Access Compliance Report Public Rights-of-Way (Curb Ramps)

Intersection ID: 13037 Main Street: S_CHURCH_ST Cross Street: QUINCEY_ST Location: W

ADA ID: 6C1E8DEF612C Ramp Type: PerpDiag Initial Pass/Fail: Fail Overall Compliance: No Severity Score: 12.5

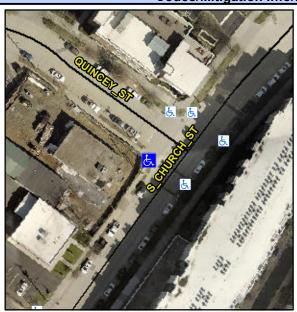
Not Found, R304.2.2

Field Measurements/Component Compliance						
	Compliance Description		Data	Compliance Description		Data
	N/A	Ramp Length (in)	96.0	No	Ramp Slope (%)	8.7
	Yes	Ramp Width (in)	48.0	Yes	Ramp XSlope (%)	0.8
	N/A	Flare Type LT	N/A	N/A	Flare Type RT	N/A
	N/A	Flare Slope LT (%)	N/A	N/A	Flare Slope RT (%)	N/A
	N/A	Flare Traversable LT?	N/A	N/A	Flare Traversable RT?	N/A
	N/A	Landing Length (in)	N/A	N/A	DWS Provided?	N/A
	N/A	Landing Width (in)	N/A	N/A	DWS Contrast?	N/A
	N/A	Landing Slope (%)	N/A	N/A	DWS Length (in)	N/A
	N/A	Landing X Slope (%)	N/A	N/A	DWS Full Width?	N/A
	N/A	Landing Curb? (Y/N)	N/A	N/A	DWS Offset (in)	N/A
	N/A	Shared Landing?	N/A			
	N/A	Gutter Ponding?	N/A	N/A	Gutter Slope (%)	N/A
	N/A	Gutter Lip Ht (in)	N/A	N/A	Gutter X Slope (%)	N/A
	N/A	Painted X Walk1?	No	N/A	Painted X Walk2?	No
		X Walk 1 Direction	To SE		X Walk 2 Direction	To NE
	N/A	X Walk 1 Width (in)	N/A	N/A	X Walk 2 Width (in)	N/A
		X Walk 1 Slope (%)	3.5		X Walk 2 Slope (%)	0.7

Remove & Replace Curb Ramp With Two New Directional Ramps or Equivalent.
